TO: Mercedes-Benz Dealer Principals, General Managers, Sales Managers, Service Managers, Parts Managers	FROM: Gregory Gunther, Department Manager, Vehicle Compliance and Analysis, Engineering Services
RE: Recall Campaign Phase 5 Launch Notification 2018030018 (Manual Steering Column) SCM Ground MY15-17 CLA-Class, GLA-Class, B-Class Electric (117, 156, 242)	DATE: April 20, 2018

RECALL CAMPAIGN PHASE 5 LAUNCH NOTIFICATION WITH **RETAIL HOLD**

SUBJECT: **Models 242, 117 and 156 Model Years 2015 - 2017**
Steering Column Module (SCM) Ground – electric steering column adjustment

Figure 1

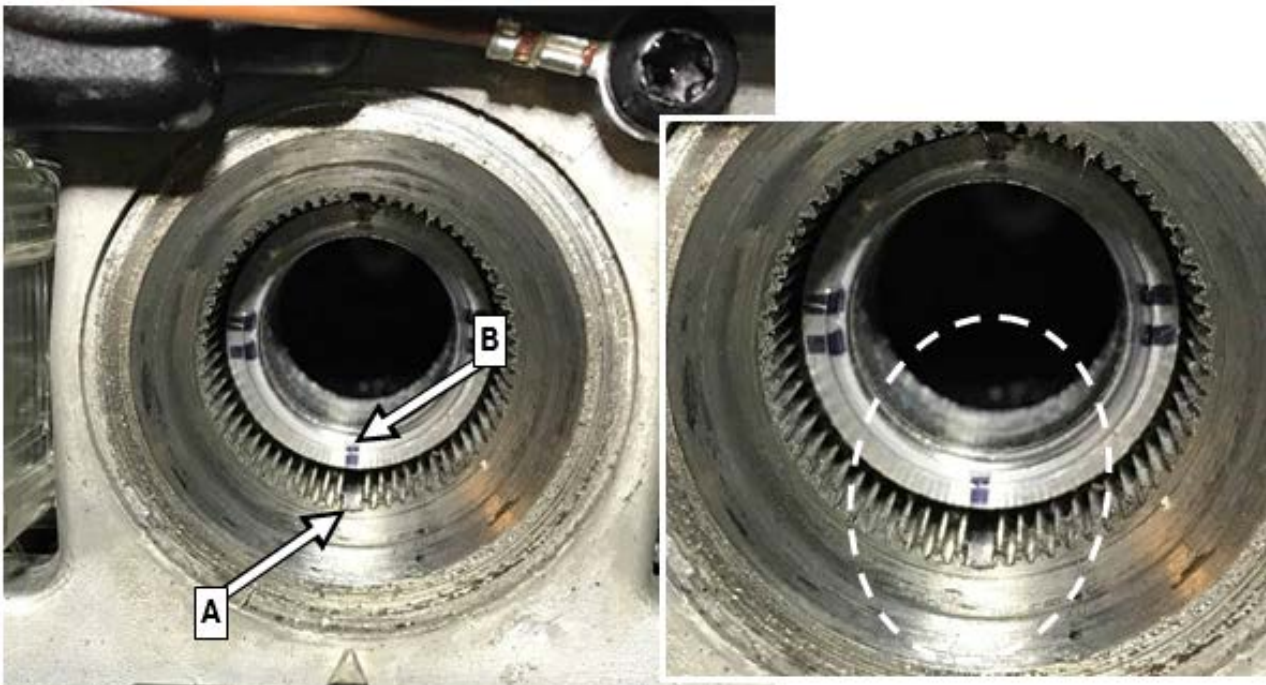
i The serrations **(A, Figure 1)** on the steering wheel must be aligned with the marking **(B, Figure 1)** on the steering shaft .

i Check the position carefully before removal and position identically during installation!

Figure 6

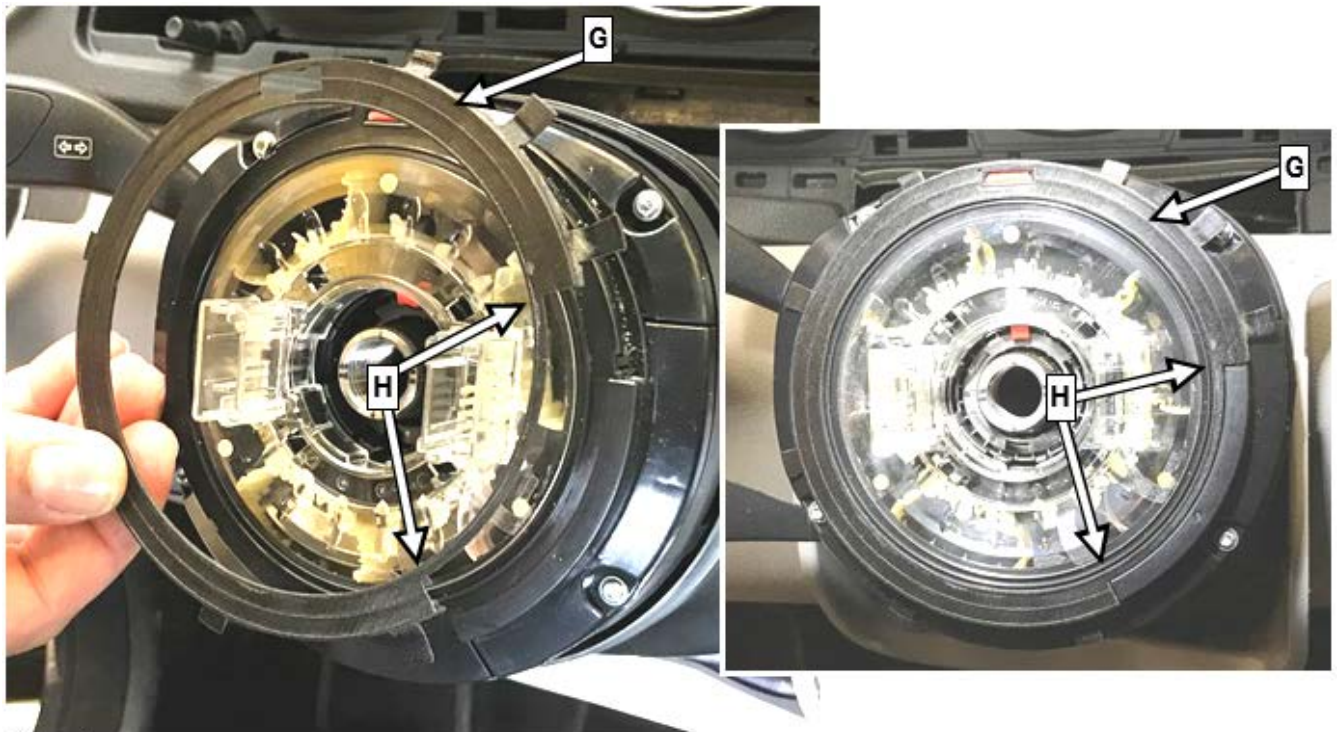
2. Subsequently position protective ring (**G, Figure 6**) on the installed Valeo steering column switch module.
 - i** Protective ring is placed on loosely and then held in place when the cover (**E, Figure 5**) is mounted.
 - i** Observe reference edges (**H, Figure 6**) of steering column switch module in relation to protective ring during assembly.
 - i** Important! It is not possible to retrofit a protective ring for steering column switch modules if the protective ring is already cast on!

- i** This operation step is omitted in the case of Valeo steering column switch modules *with* modification

Figure 7

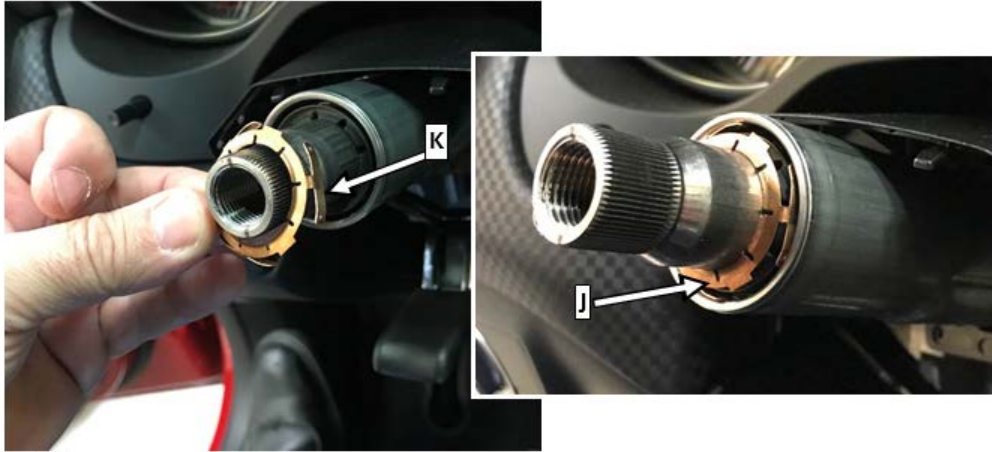
- i** **Figure 8:** Sample depictions of a contact bridge in final stop position on the steering column.
- i** The contact tabs disappear completely into the bearing outer race of the steering column!

Figure 9

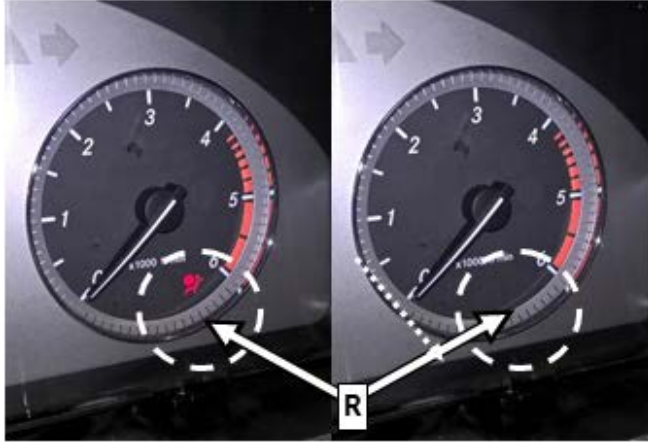
6. Install steering column switch module.
 7. Assemble in reverse order.
Connect ground line to on-board electrical system battery.
 8. Turn transmitter key in electronic ignition lock to **position 1** and check whether the Airbag indicator lamp (**L, Figure 9 or 10**) goes out permanently after a few seconds.
- i** The SRS check is thus completely ensured after airbag replacement!
